## **APPENDIX A RESPONSE TO AGENCY COMMENTS**

**Response to Comments on the Draft [Final] Remedial Action Construction Summary Report, Parcel E-2 Phase II, Hunters Point Naval Shipyard, San Francisco, California, June 2020, DCN: APTM-2005-0013-0047**

*Comments by: Nina Bacey, California Department of Toxic Substances Control, comments dated March 5, 2020; follow-up on July 1, 2020.*

Advance Planning Report  
for  
**LAND EXCAVATION AND FILL**

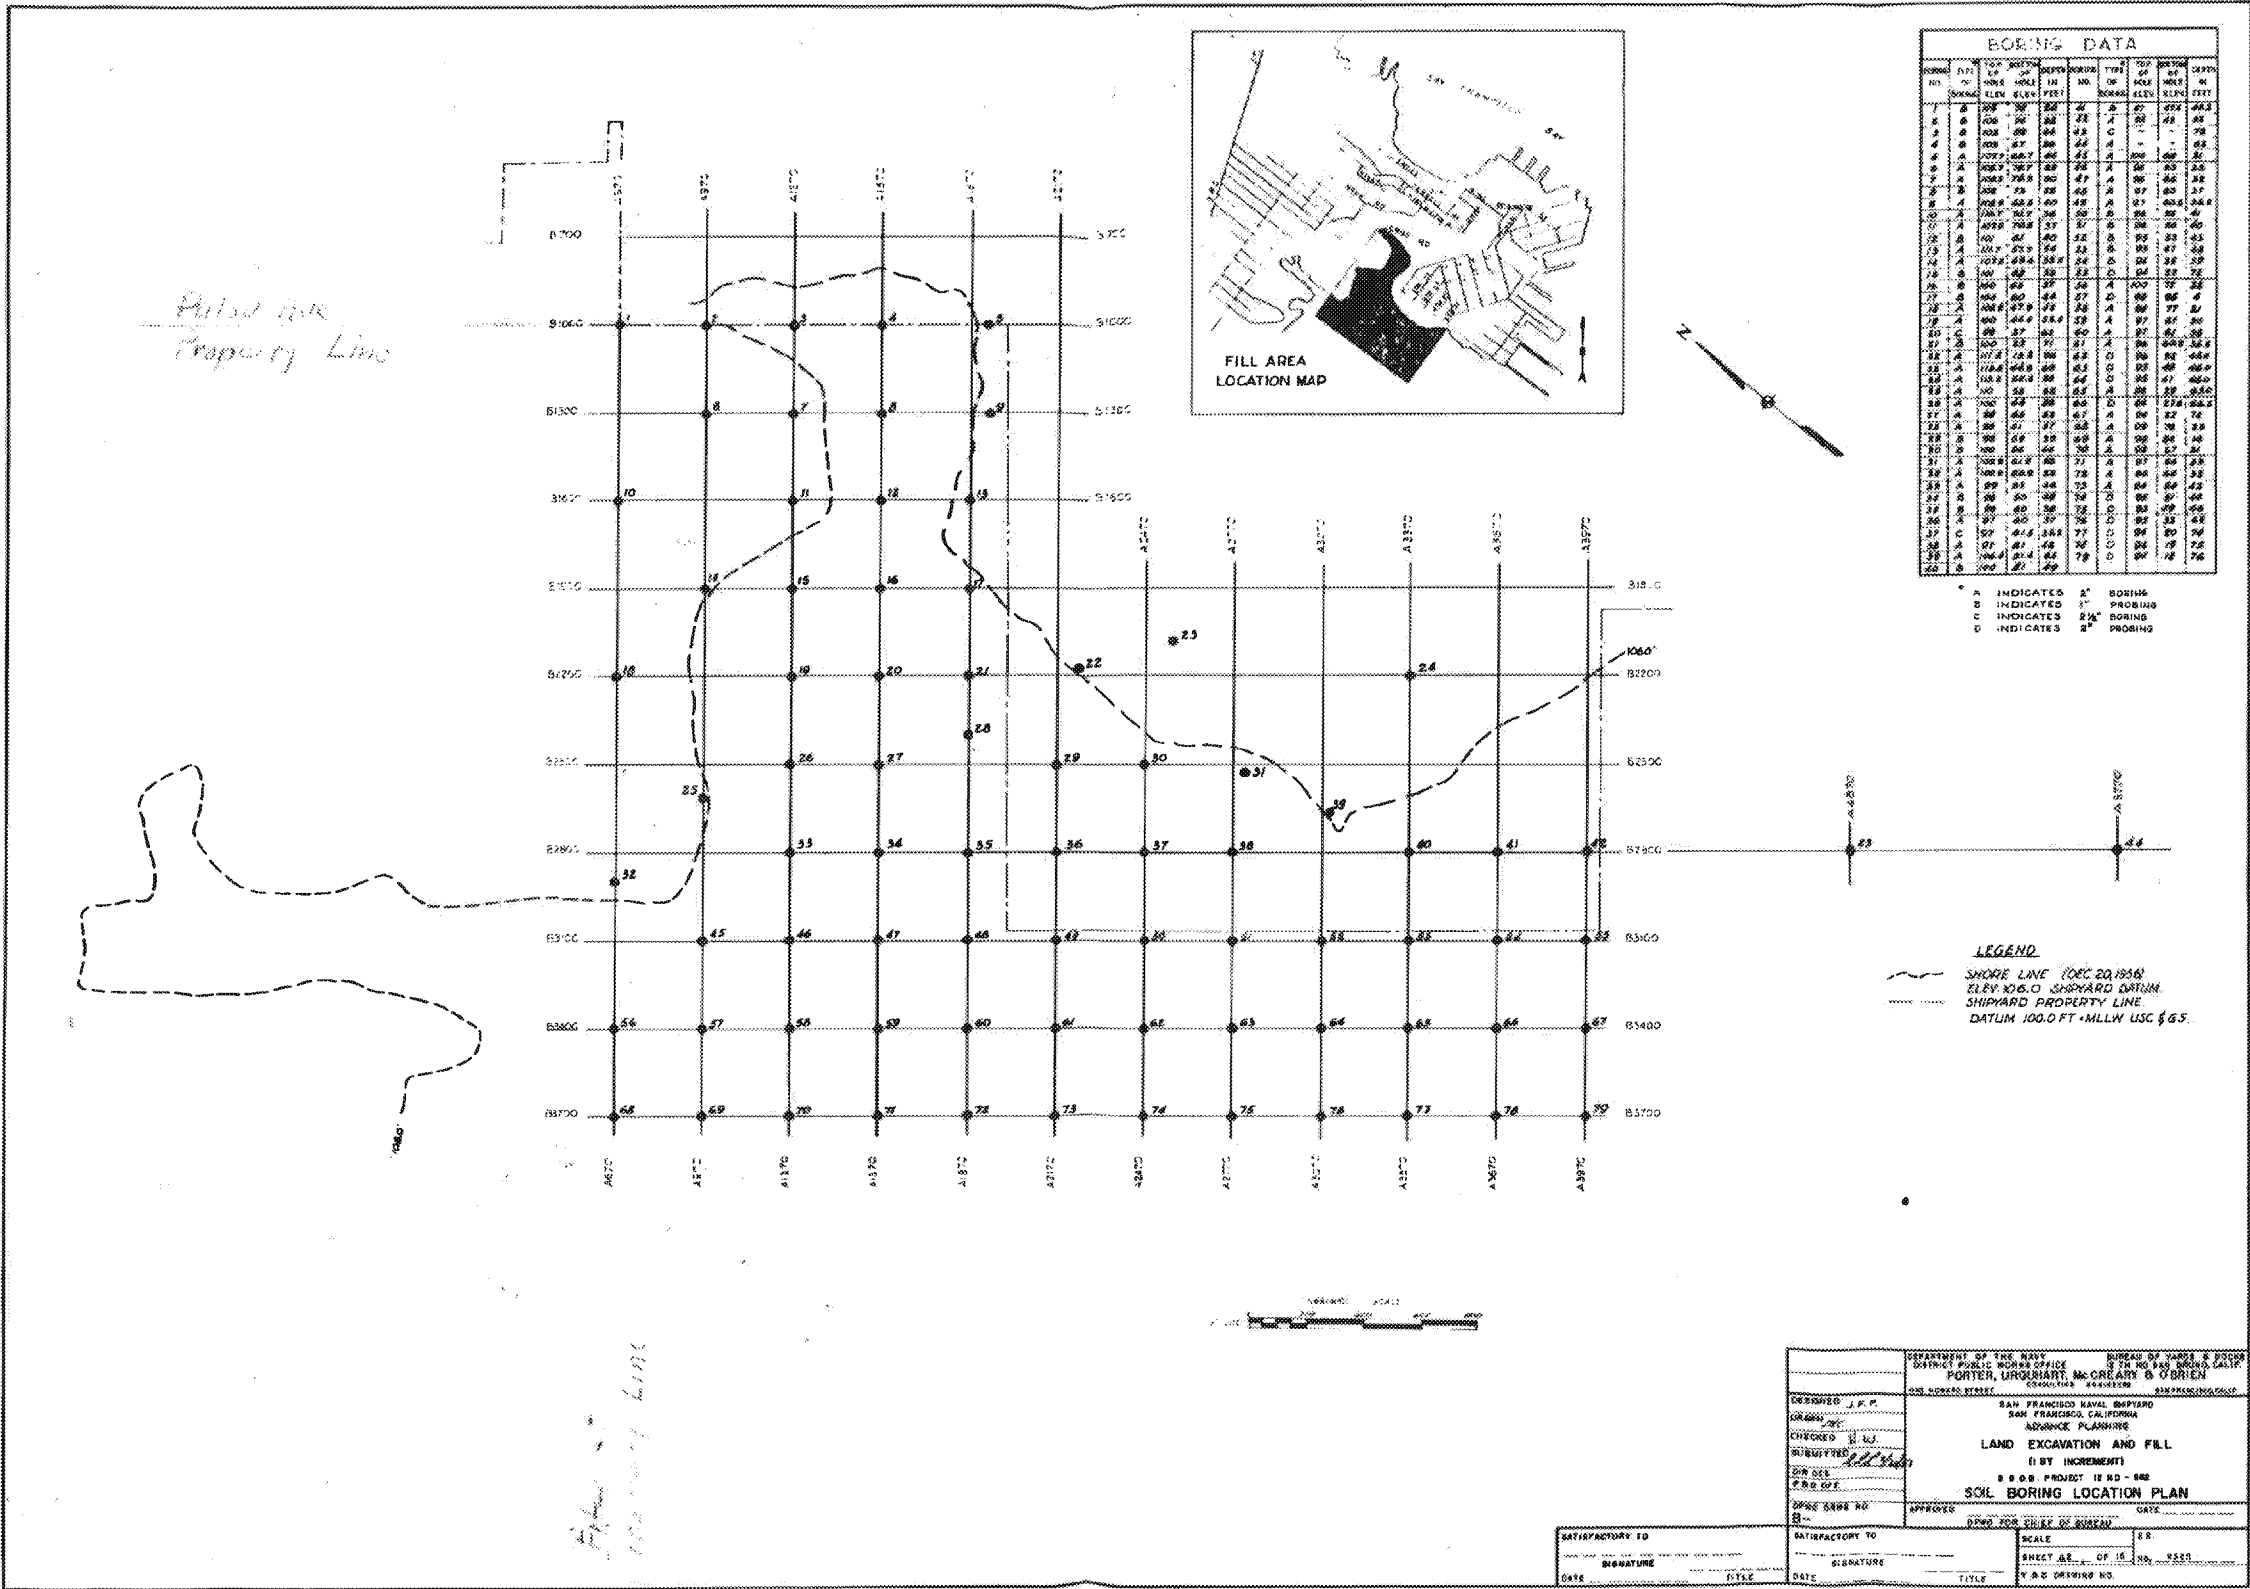
Please see response to Water Board comment #15. The rationale for the conclusion that this obstruction is bedrock is based on the historical boring logs as provided herein for review. The Navy will evaluate the Parcel E-2 RAMP (ERRG, 2014) and make revisions as necessary to ensure appropriate measures are put in place to adequately monitor the as-built effectiveness of both the upland and nearshore slurry wall systems.
